Your Comment on the Rangitoopuni application

Comments on a fast-track consenting application

Regarding fast-track project: Rangitootuni

Fast-track Reference: FTAA –2504-1055

Figure 1: Development project area (pink line). Blue dots = bats detected, black empty circles = bat survey no bats recorded.

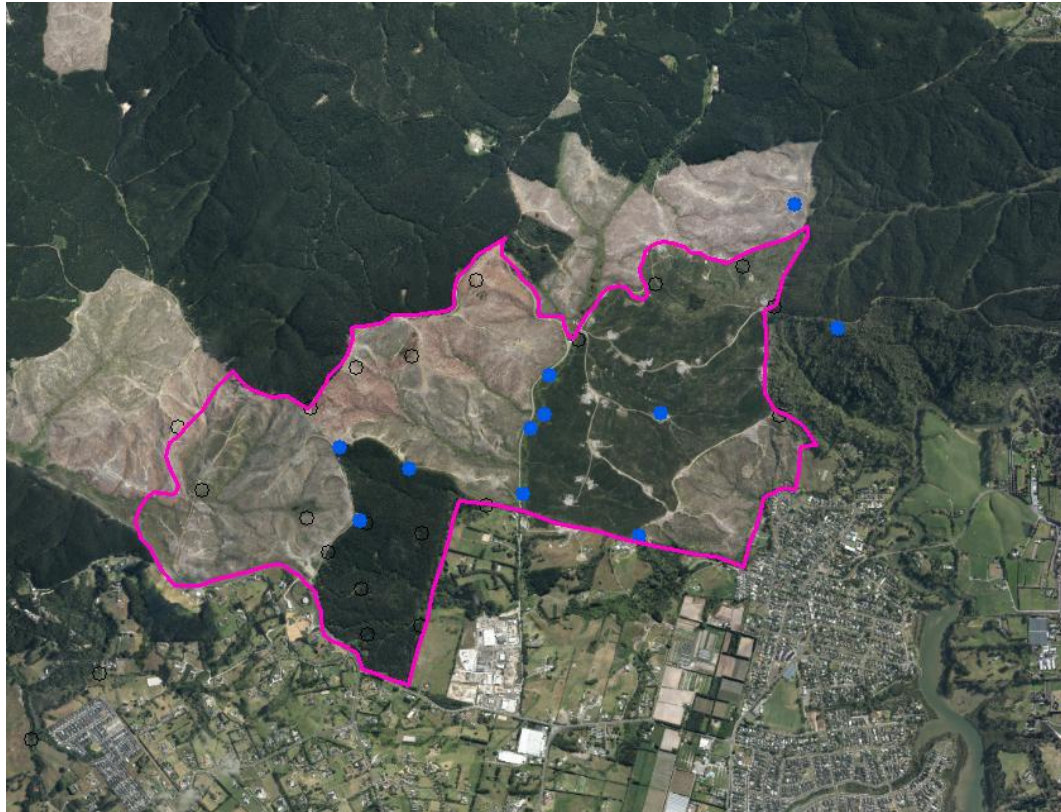
2.13 Surveys have detected long-tailed bats in the project site and the EIA confirms that they are expected to be present in the area as a highly mobile species with a known population at Riverhead Forest⁸. Figure 1 below shows where long-tailed bats have been detected (including more recent March 2025 surveys provided post lodgement). Long-tailed bats have a conservation status of 'Nationally Critical' which is the highest threat category before extinction. The project site is considered to have 'very high' ecological value given their presence⁹. The remaining section of mature exotic forest (in the south-western part of the site) is likely to contain suitable roosting trees for bats and will result in permanent loss of very high value long-tailed bat habitat.
